Design Rationale

Rationale for Density & Response to UDP Minutes

RESPONSE TO UDP MINUTES FEB 27TH, 2013

REDUCE HEIGHT ②

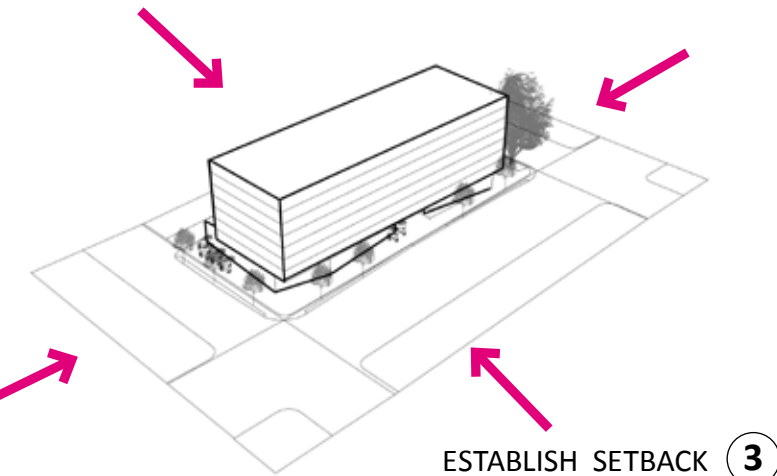
Previous UDP #2 scheme went up to 10 floors. This site does not have same restrictions as rest of cambie corridor

But proximity to city hall and wish to keep project below its podium lead us to reduce height to 8 floors

ESTABLISH SETBACK ③

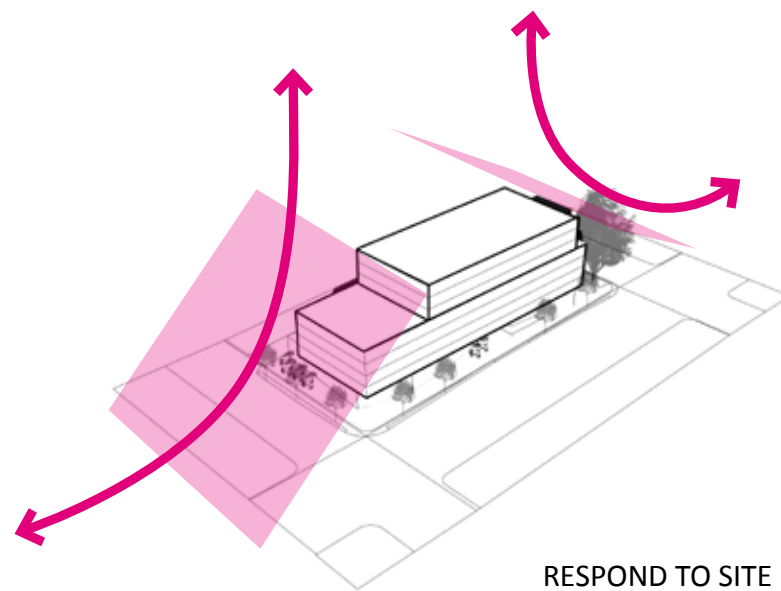
Outright setback of 2' is required on all side. BUt Heritage trees along 13th and character area to East push greater setbacks along these edges. Introduction of Lane and re-positioning of heritage house further push setbacks. At ground plane further setbacks at corners and at centre of site to improve public realm and create a seating opportunities for public.

RESPOND TO SITE ④

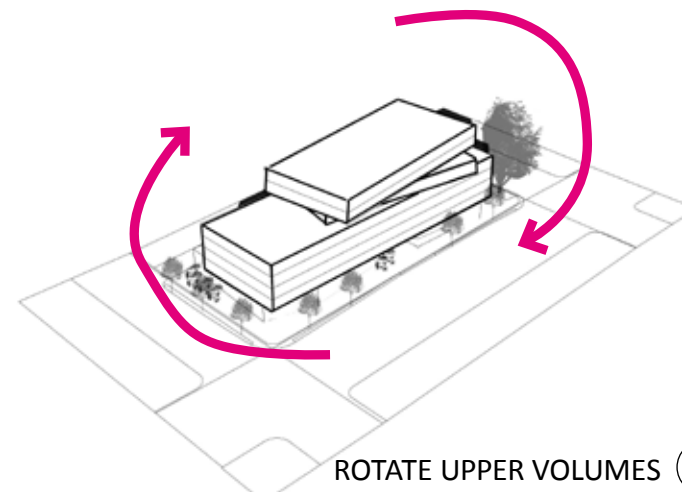
To improve relationship to City hall and to neighbours to South the building pushed down to 5 floors with portion at 8.
